TO: District of Columbia Zoning Commission
FROM: Jennifer Steingasser, Deputy Director- Development Review & Historic Preservation
DATE: February 28, 2014
SUBJECT: Preliminary Report – ZC 13-12 – Consolidated and Preliminary PUD at 1333 M Street, SE, with Associated Map Amendment

I. OFFICE OF PLANNING PRELIMINARY RECOMMENDATION

Figure 1. Consolidated and Preliminary PUD Site Plan

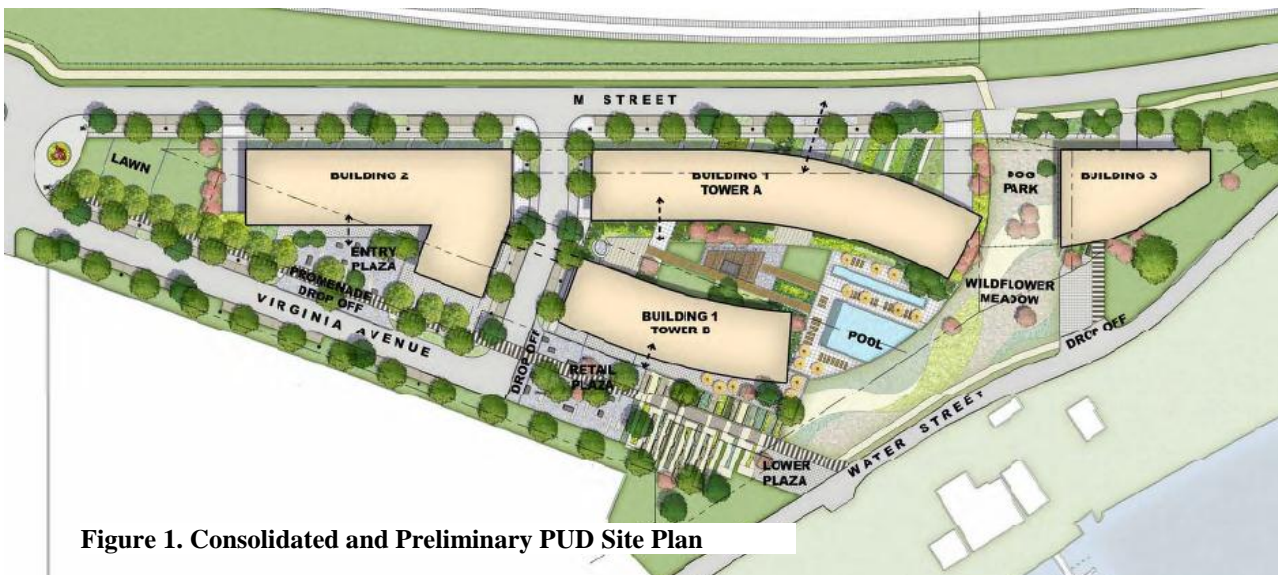
Relief would be required for varying roof structure heights, rear and side yards, open courts, loading berth lengths, locating parking for one building on a different theoretical lot, and length of consolidated PUD approval.

Figure 4. Consolidated PUD - as of 10-20-13

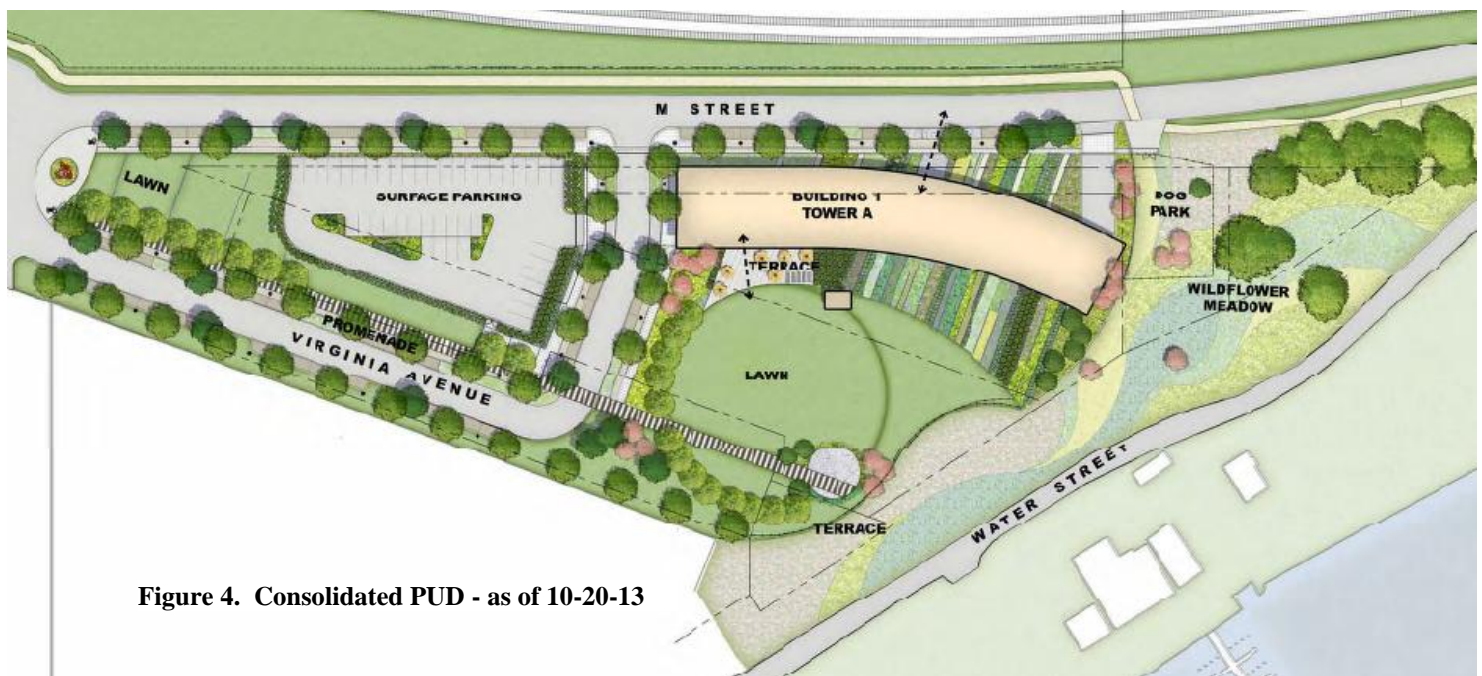
The architecture of Building 1, Tower A is bifurcated. The north side is intended to respond to both the red brick industrial buildings at the nearby Navy Yard and to traditional Capitol Hill facades with their masonry construction and punched windows. The south side is intended to connote the open feel of the waterfront it faces and capture views with extensive use of glass.

OP has encouraged the applicant to apply fresh approaches to the project’s architecture, and recommends the applicant continue to study and refine the building’s design with the following concerns in mind:

- The appropriate color and materials comprising the north façade’s High Pressure Laminate (HPL) panels
- Whether alternative façade designs could and should establish a subtler interplay of elements of the contrasting north and south facades.
